**DEVIATION REQUEST
AND DECISION FORM IN
ASSOCIATION WITH A
REQUEST FOR A PUD
MODIFICATION FROM
THE ECM**

Project Name : Waterside
Schedule No.(s) : 71114-04-112
Legal Description : All of the waterside condominiums subdivision, recorded in Plat Book 2, At Page 47 Records of El Paso County, Colorado

WATERSIDE TOWNHOMES
 DEVIATION REQUEST - ECM SEC. 2.2.4.B.7.
 FIGURE 2-17, TABLE 2-7
 PCD FILE NO. PUDSP-22-009

PROPOSED TYPICAL SECTION – PRIVATE ROADWAY TRACT

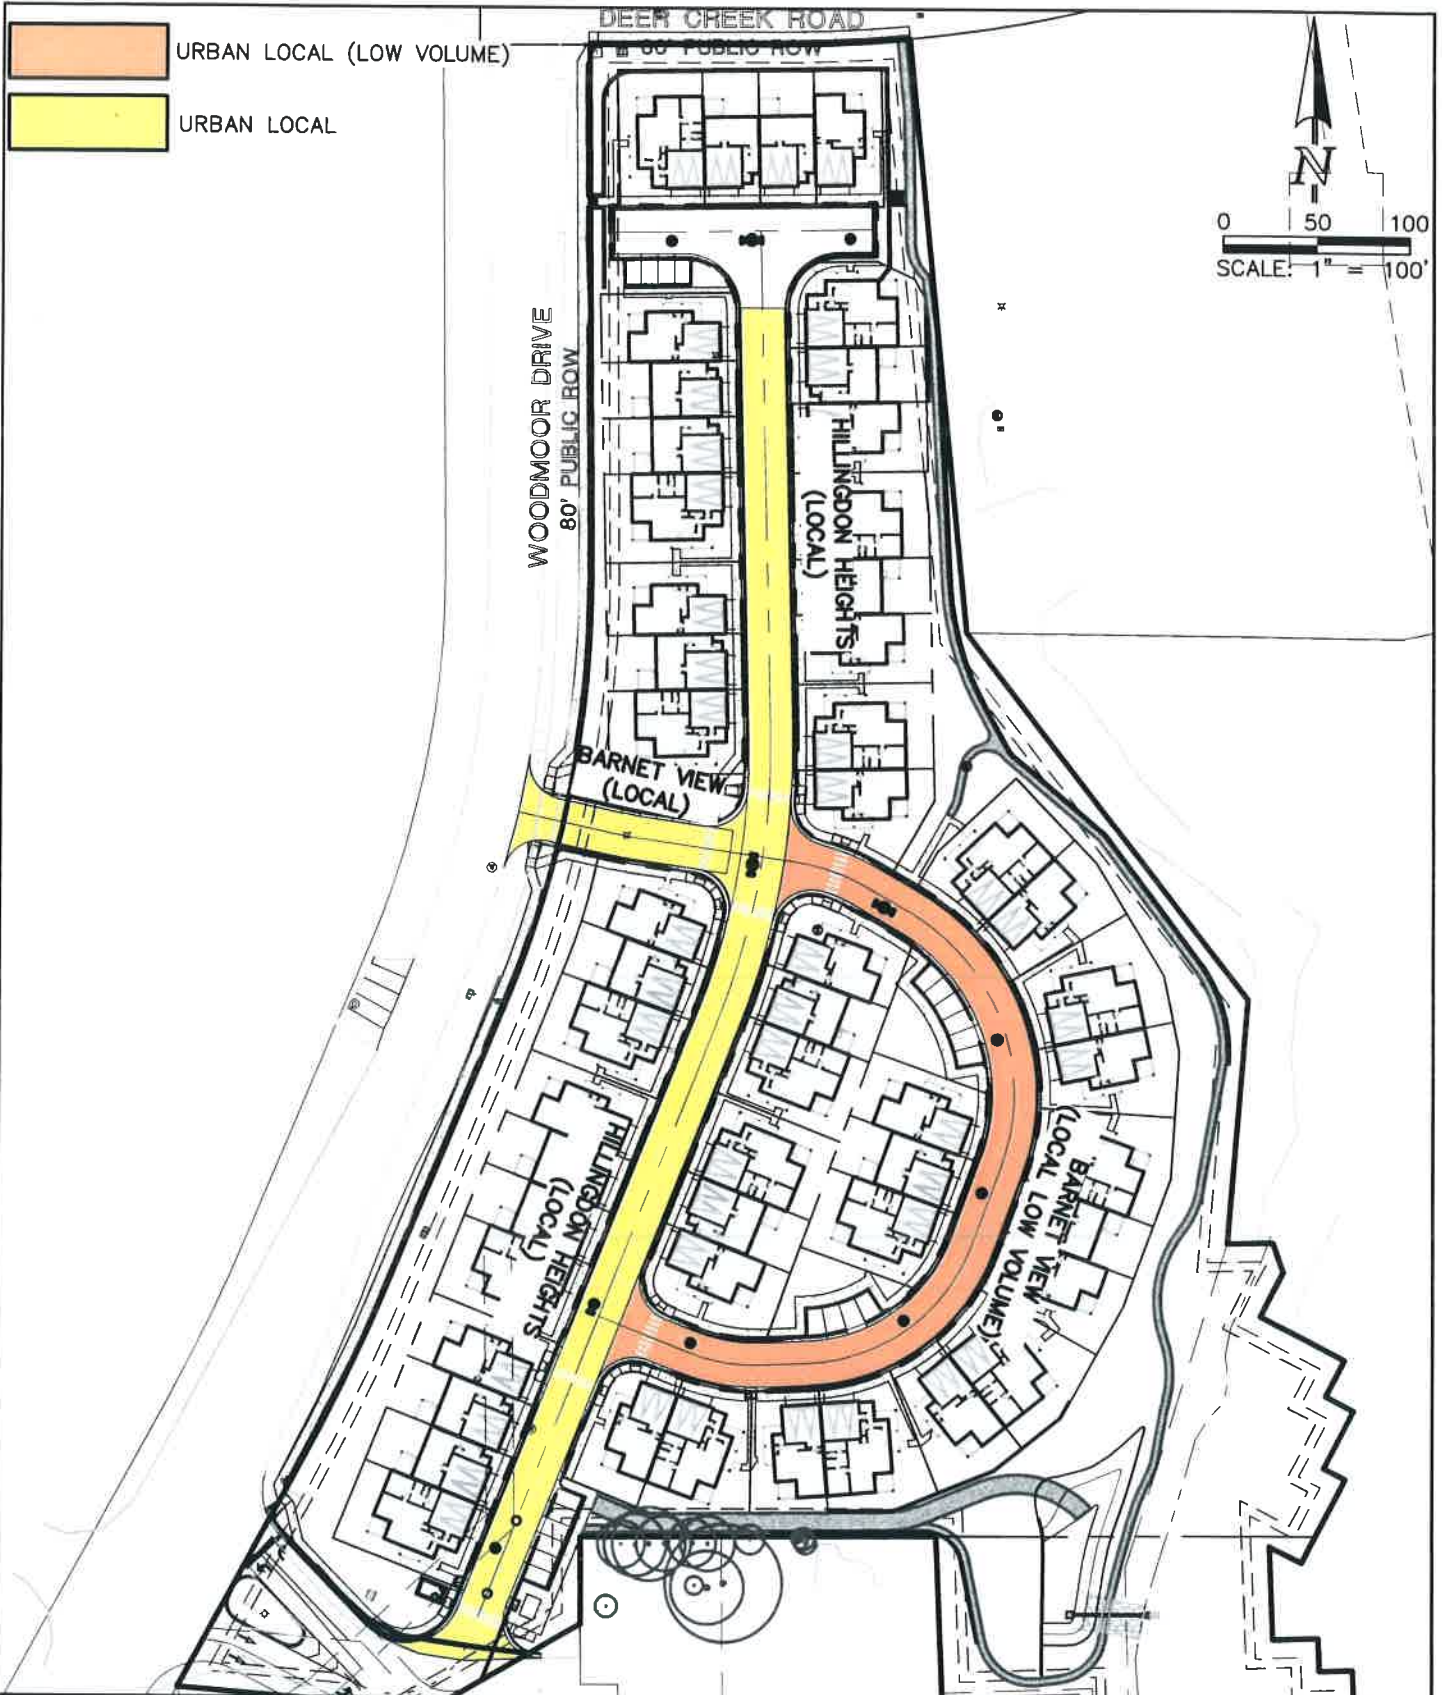
Typical urban local cross section (50' ROW with 30' asphalt mat) – ECM 2.2.4.B.7 (Fig. 2-17)
Table 2-7
Standard Detail SD_2-2

200' minimum tangent length between two Broken Back curves – ECM2.3.3.F.3

A standard county public urban local roadway is contained within a 50' wide public right of way (with a 30' wide asphalt mat). The proposed private street section is contained within a 29' wide private tract (owned and maintained by the Homeowners Association) and includes a 24' wide asphalt mat. All private roads to be built using county standard curb and gutter, signage and pavement thickness, as well as adhering to county maximum grade criteria. See attached proposed street section, and exhibit depicting locations of urban local and urban local (low volume) private roads. Broken Back curve tangent lengths of 30.07' and 36.58' are proposed on the small looped private Barnet View, where 200- minimum tangent length is required (same as an arterial roadway).

- HILLINGDON HEIGHTS – URBAN LOCAL ROADWAY (MIN. 200' CL RADIUS)
- BARNET VIEW BETWEEN WOODMOOR DRIVE AND HILLINGDON HEIGHTS – URBAN LOCAL ROADWAY (MIN. 200' CL RADIUS)
- BARNET VIEW EAST OF HILLINGDON HEIGHTS – URBAN LOCAL (LOW VOLUME) (MIN 100' CL RADIUS)
- 16 HOMES = 160 ADT < 300ADT
- NO TANGENT LENGTH MINIMM FOR LOCAL (LOW VOLUME) IDENTIFIED IN ECM

The Deviation is only valid until and unless the Board of County Commissioners approves the Planned Unit Development Modifications.
